SERVICE BULLETIN #1033

SUBJECT TIGHTENING CYLINDER HEAD SCREWS

MODEL **S44A** and S55A DATE 10/30/58

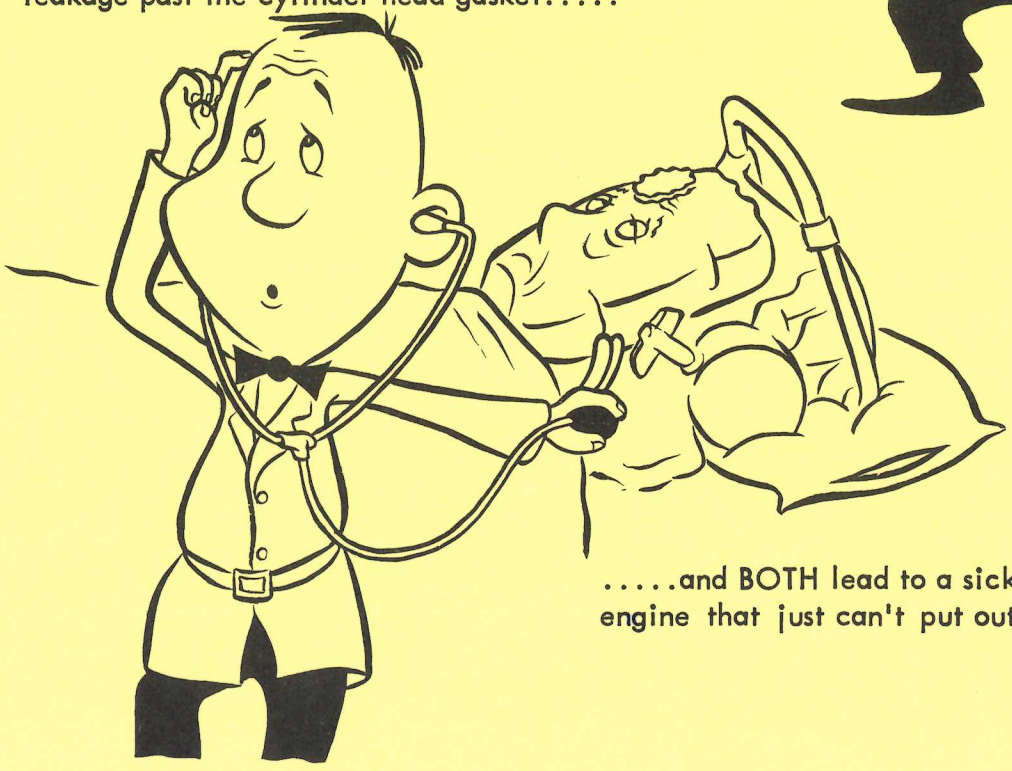
When tightening cylinder head screws, use a torque wrench for accuracy and tighten the screws to 50 to 55 inch/pounds.

If you over-tighten, you may strip the threads.....

If you don't tighten enough, you run the risk of compression leakage past the cylinder head gasket.....

.....and BOTH lead to a sick, sick, SICK engine that just can't put out production!
